QUALIFICATION OF PURGE AND VENT VALVES

WASHINGTON PUBLIC POWER SUPPLY SYSTEM

WNP-2 SITE

QUALIFICATION OF PURGE AND VENT VALVES AT WNP-2

FIGURE 2

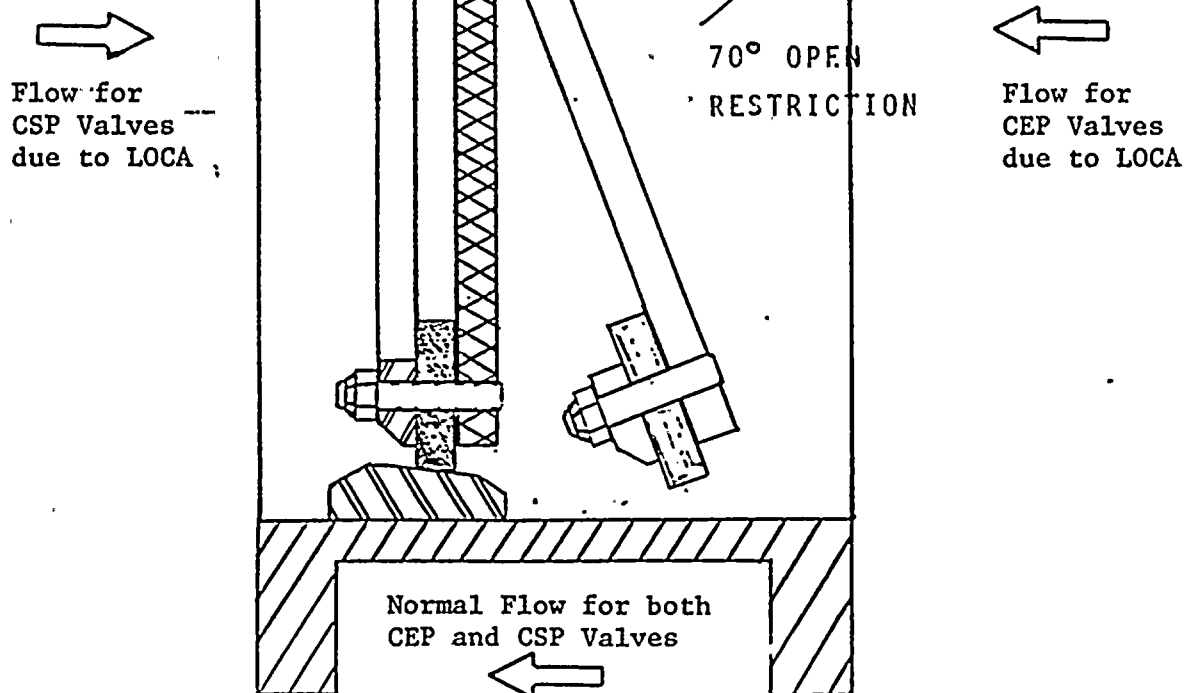
For normal flow considerations at WNP-2, the valves are installed in the manufacturer's preferred orientation. Therefore, the exhaust valves (CEP) are installed in the preferred direction of flow for both venting containment and flow which is a result of LOCA. However, the supply valves (CSP) are installed for preferred flow toward containment and will be subjected to non-preferred flow direction during postulated LOCA condition (see figure 2).

These CSP valves are potentially subject to reversed torque due to flow out of containment. To assure that only positive closure torque occurs, all valve openings will be limited to 70° and therefore precluding the negative flow induced torque.

Figure 3

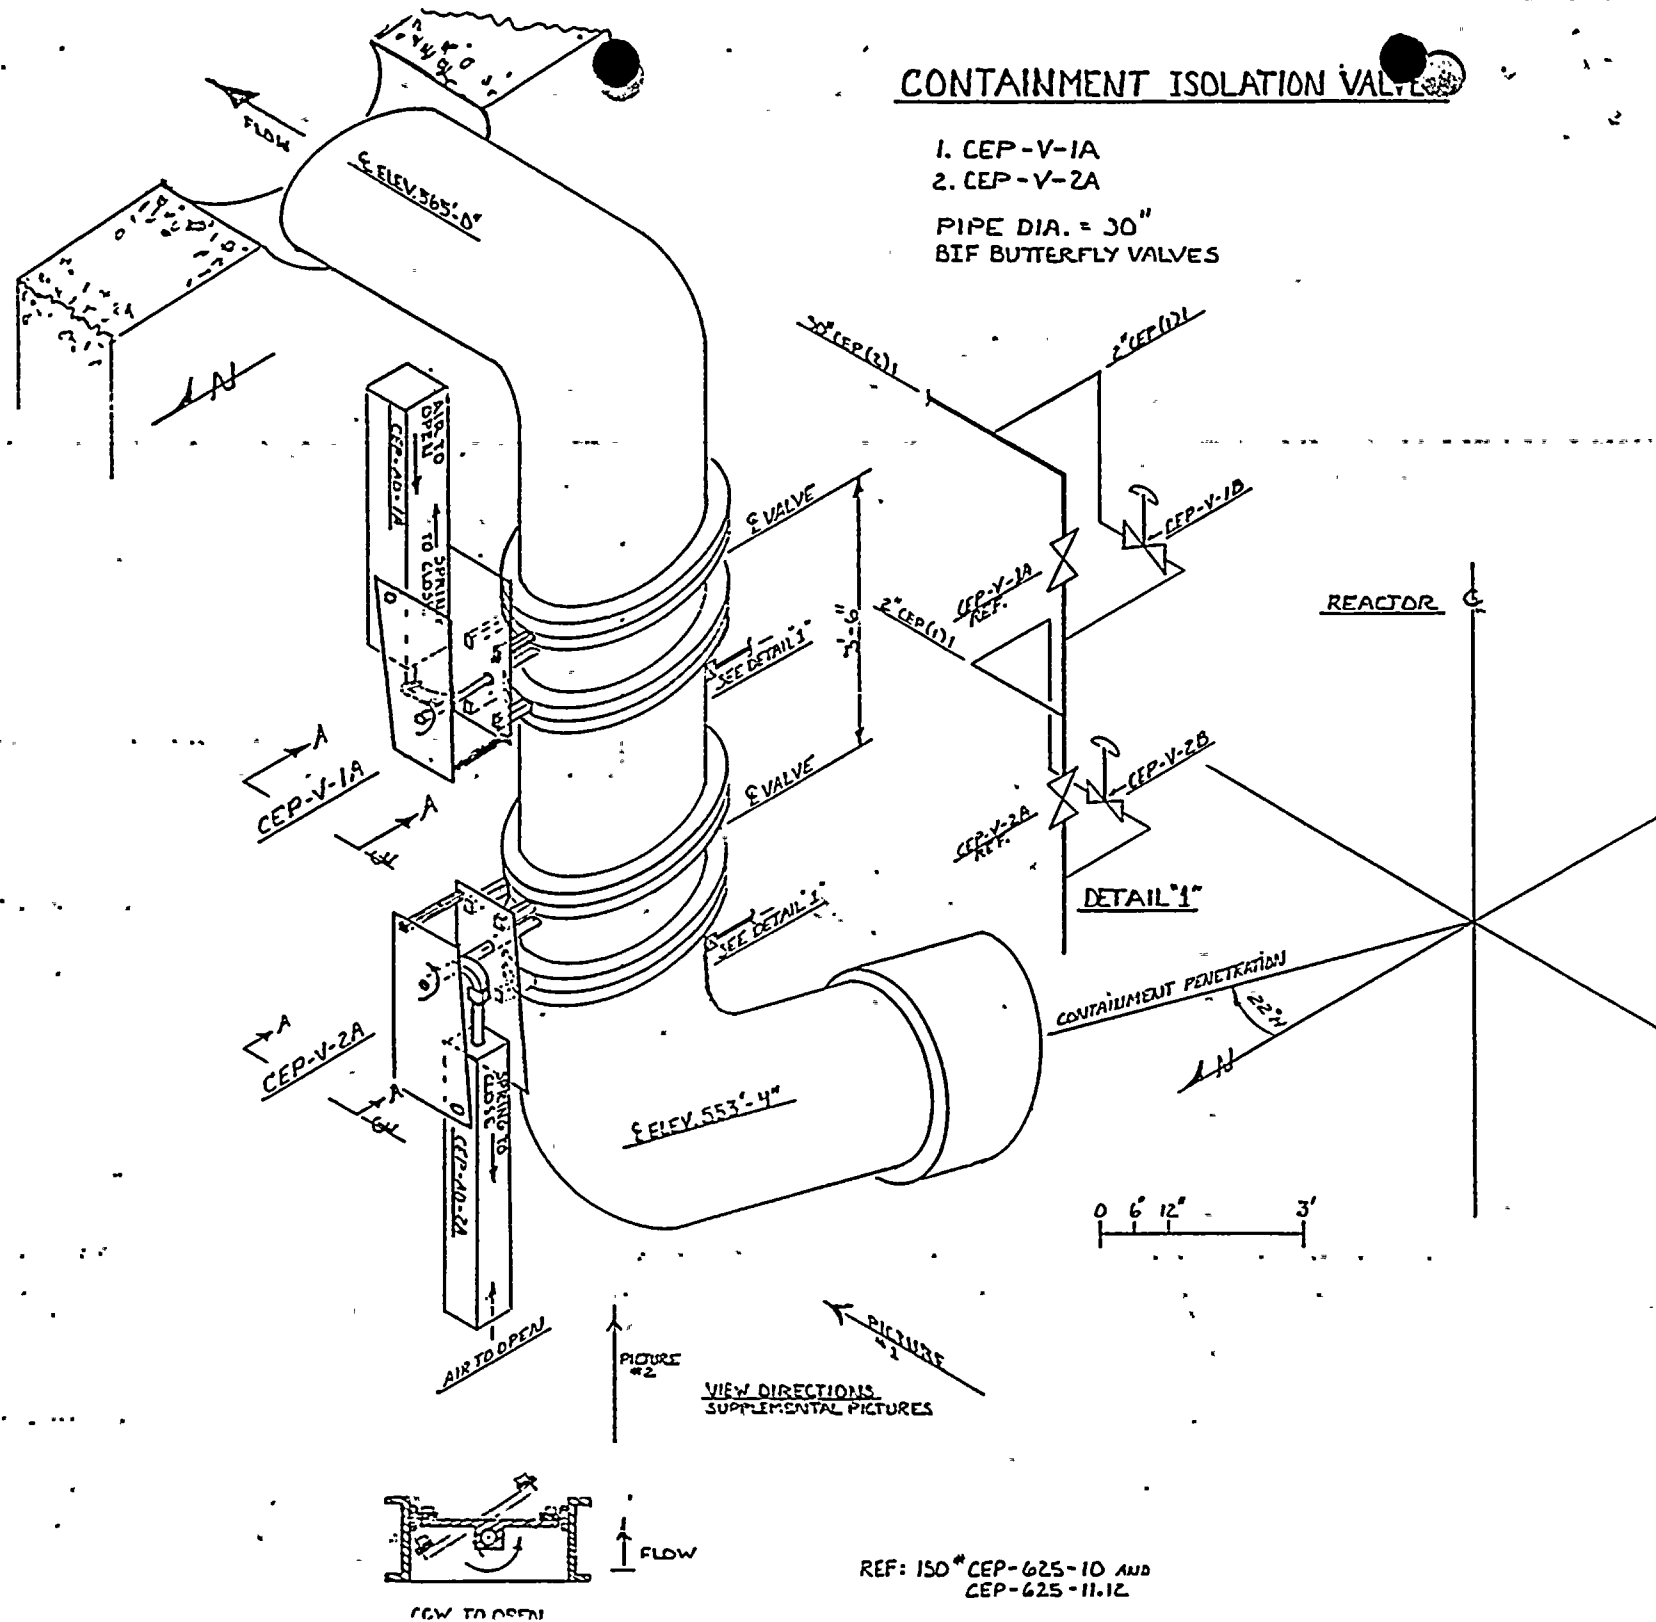
Detailed valve installation information was not provided for each valve such as:

- Item 1. Direction of flow.
- Item 2. Disc closure direction.
- Item 3. Curved side of disc, upstream or downstream (asymmetric discs).
- Item 4. Orientation and distance of elbows, tees, bends, etc. within 20 pipe diameters of valve.
- Item 5. Shaft orientation.
- Item 6. Distance between valves.

Figure 3	CEP-V-1A and CEP-V-2A
Figure 4	CEP-V-3A and CEP-V-4A
Figure 5	CSP-V-1 and CSP-V-2
Figure 6	CSP-V-3 and CSP-V-4

Disc closure directions are provided in Figures 1 through 4. For installations downstream from an elbow, LOCA induced flow tends to help close the valve.

The BIF valves used at WNP-2 do not have a curved side and the air foil lifting characteristics associated with this type of configuration will not exist on WNP-2 valves. The location of the seal ring is shown in figures 3 thru 6.

Detailed valve installation information for piping configuration is provided in Figures 3 through 6.

Detailed valve installation information for shaft orientations is provided in Figures 3 through 6.

Detailed valve installation information for the distance between valves is provided in Figures 3 through 6.

FIGURE # 7

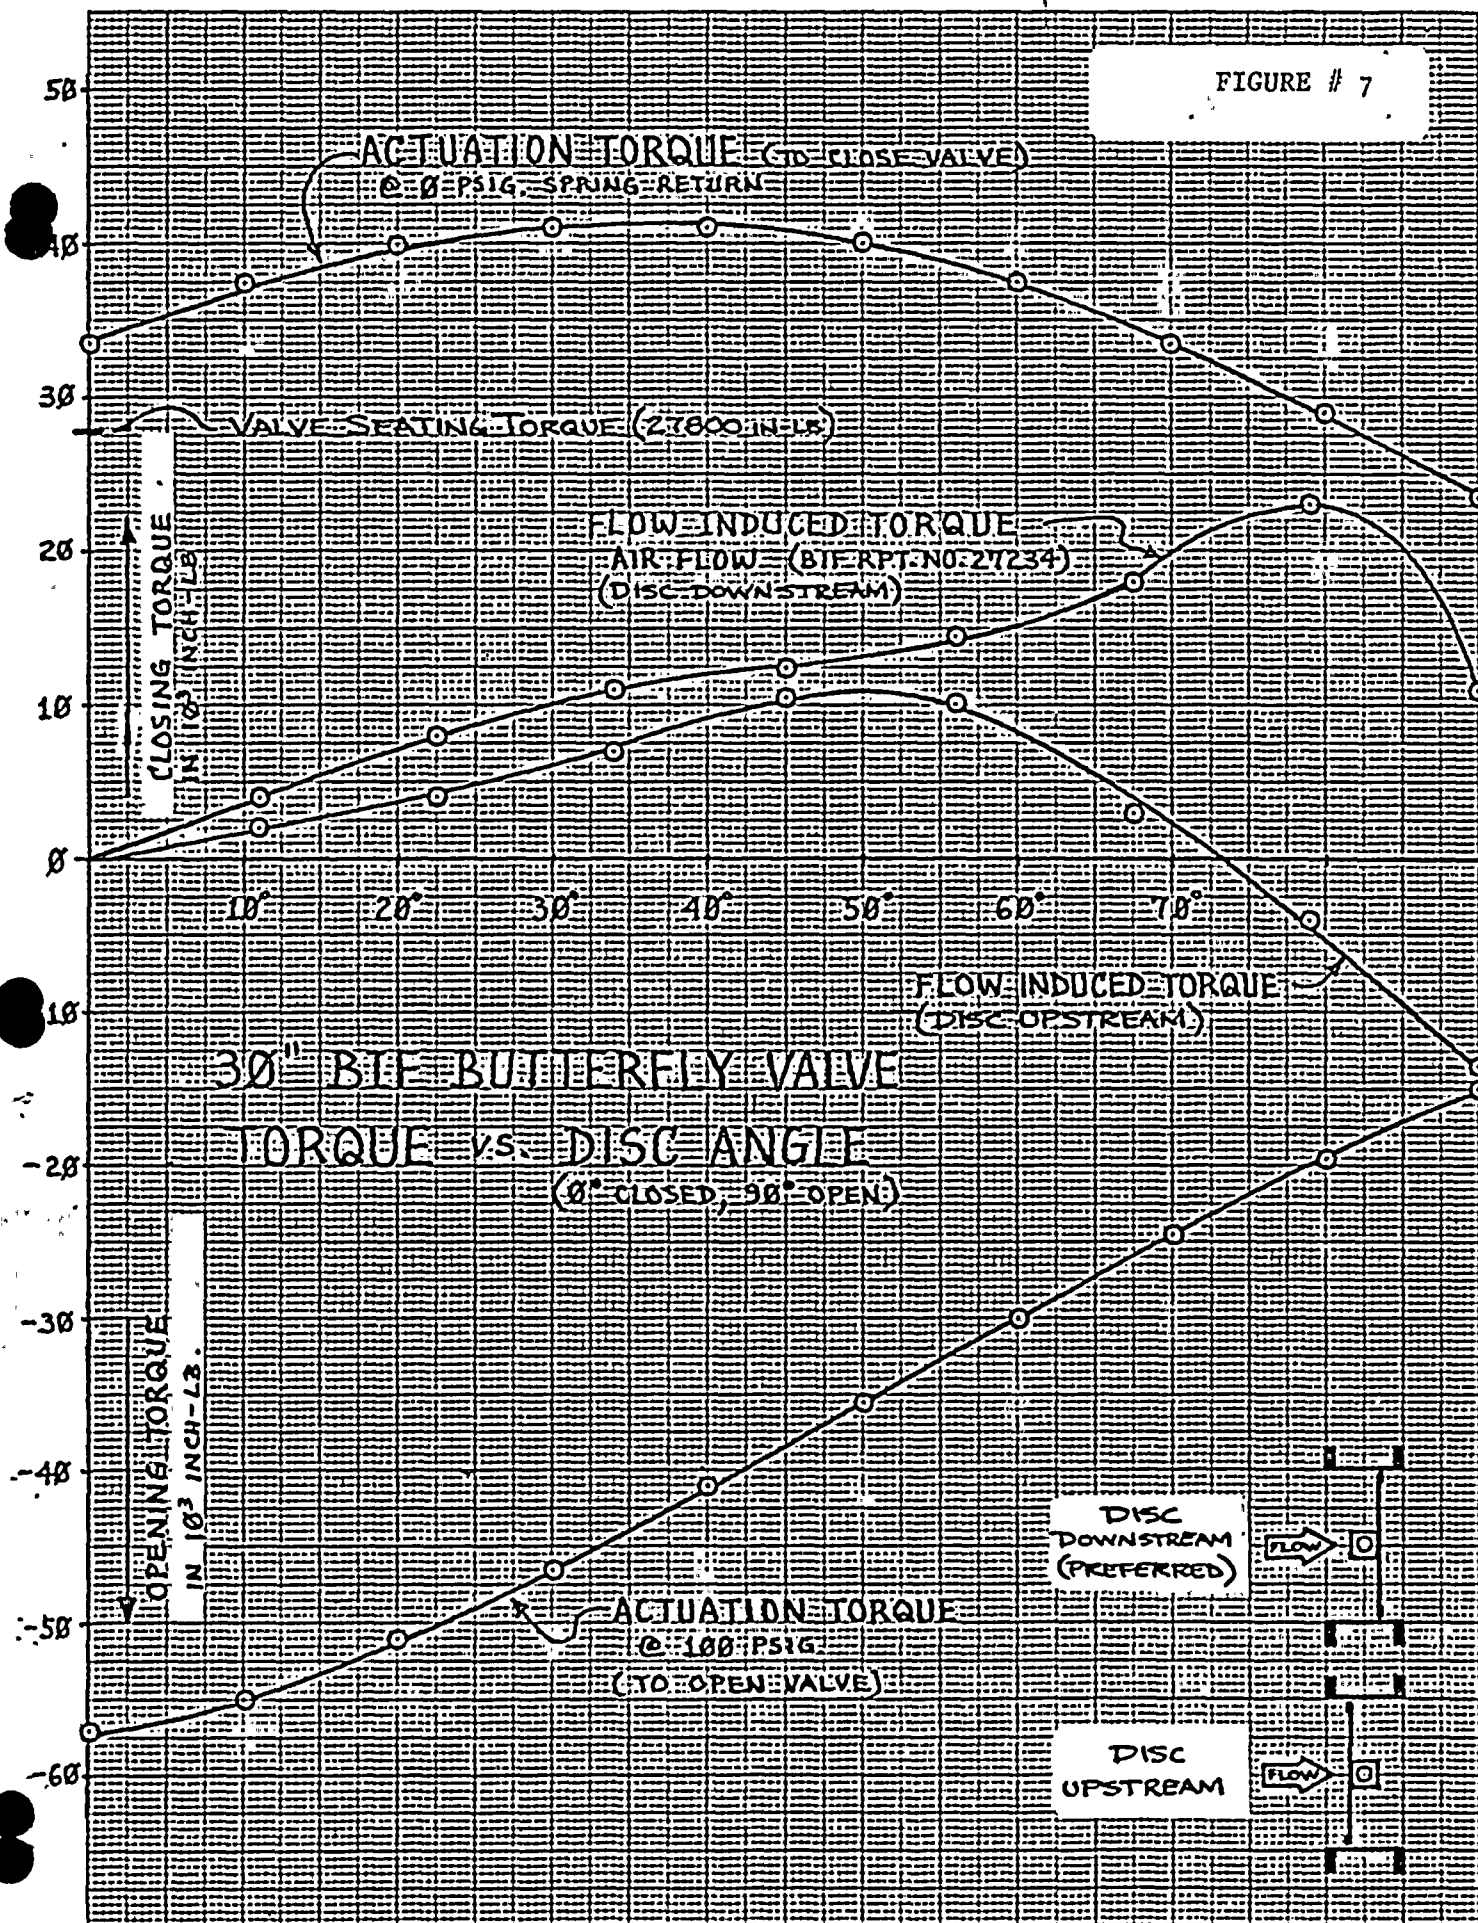
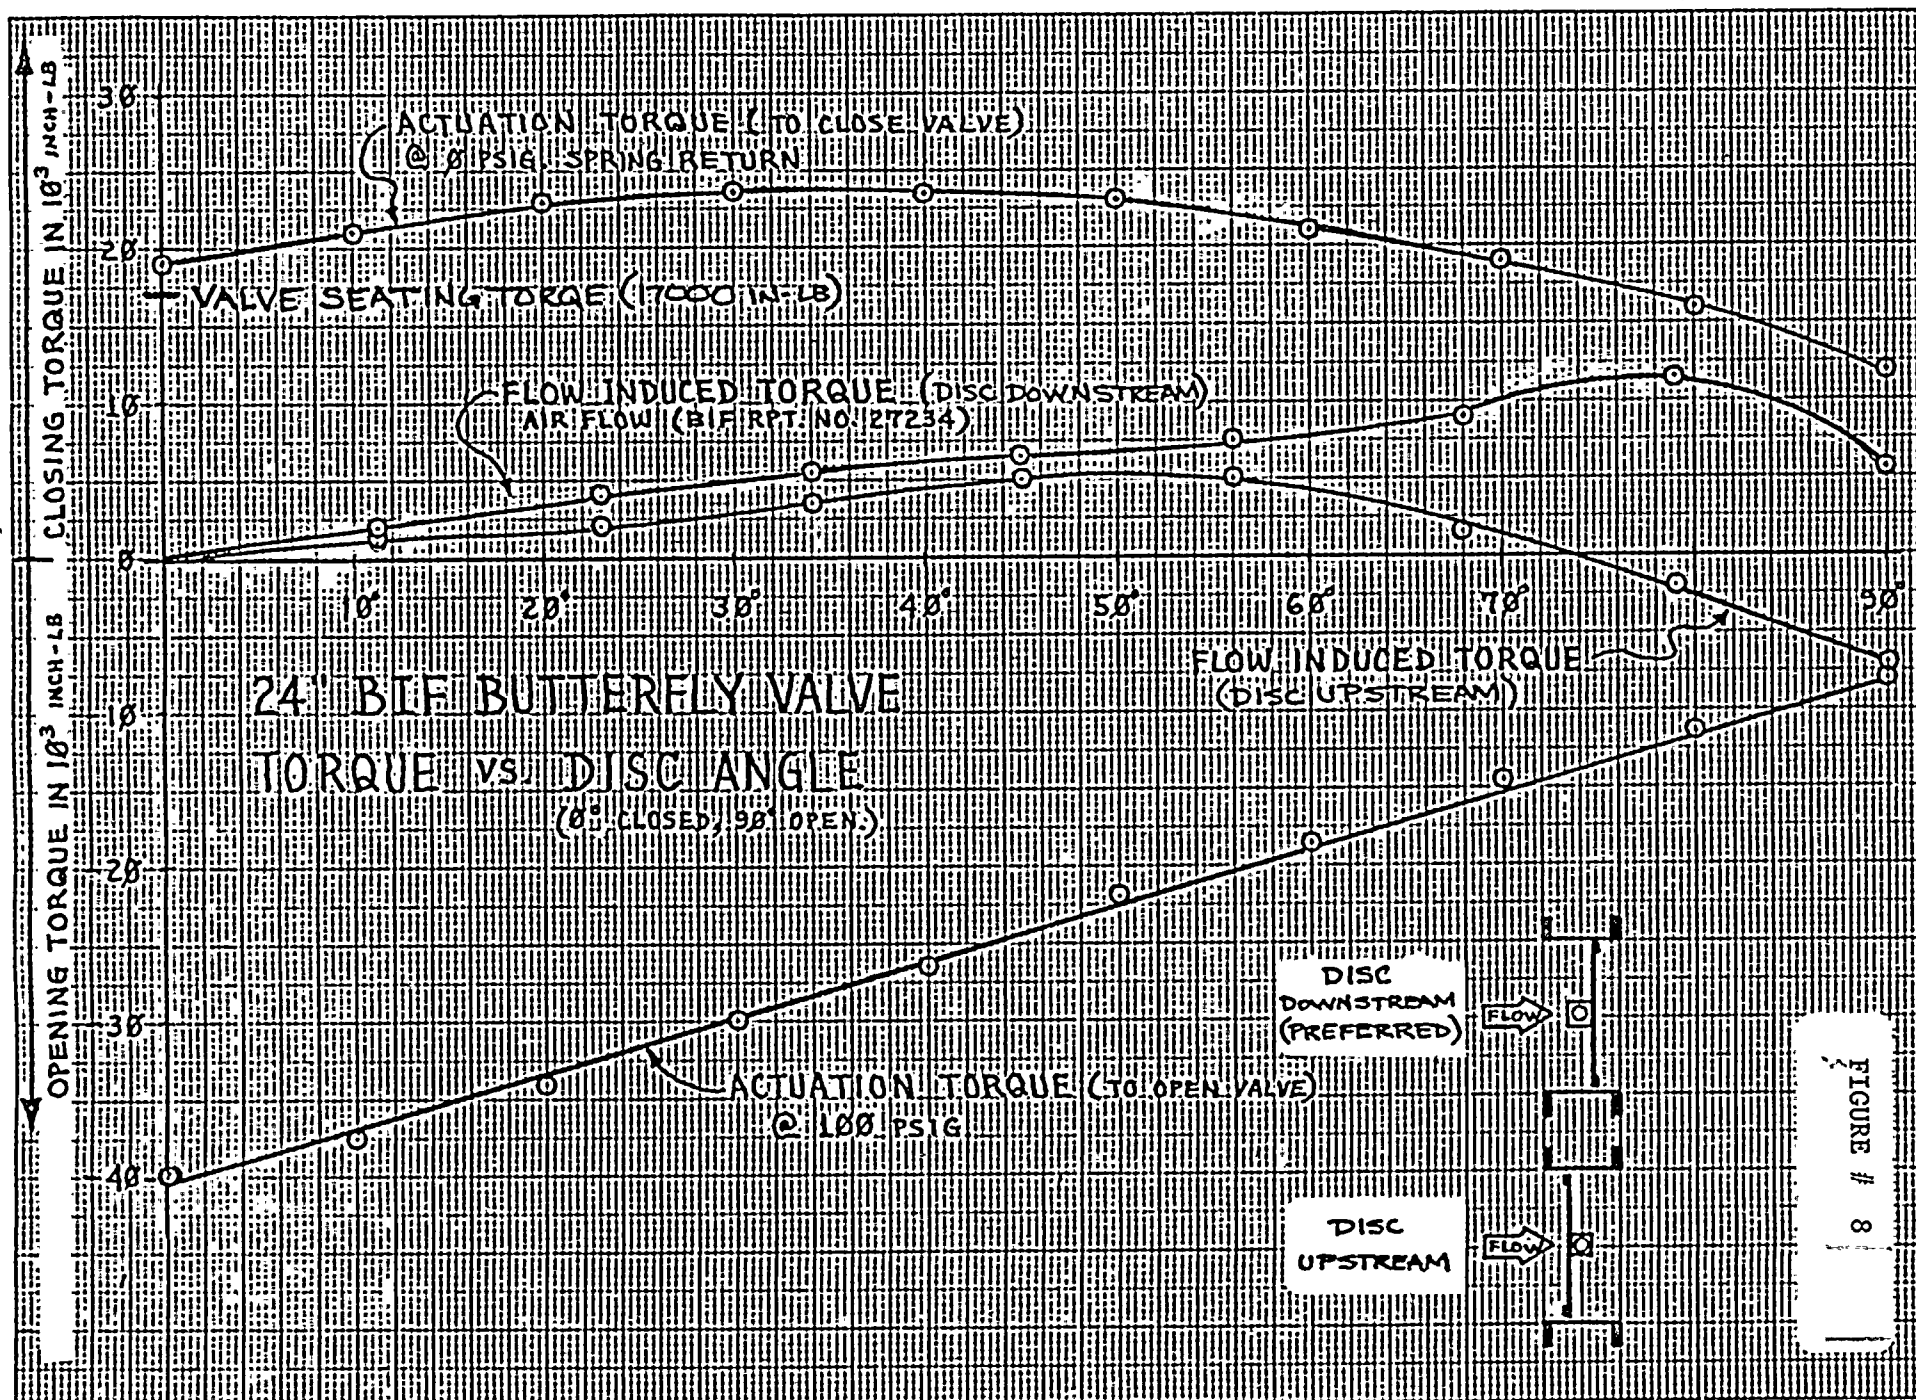
The worst case geometry at large angles of valve openings can produce very high torques that would be considerably larger than seating torque. These dynamic torques should be used in the structural analysis instead of seating torques.

The qualification analysis used the larger of either seating torque or flow induced dynamic torques.

Valve Size	Dynamic Torque (Closure)	Actuator Spring Torque Available (Closure)	Margin of Safety
24"	1,200 In. Lb.	18,600 In. Lb.	Not Applicable
30"	2,400 In. Lb.	33,700 In. Lb.	Both Loads Provide Closure

Figures 7 and 8 show torques for both valve sizes at all angular positions.
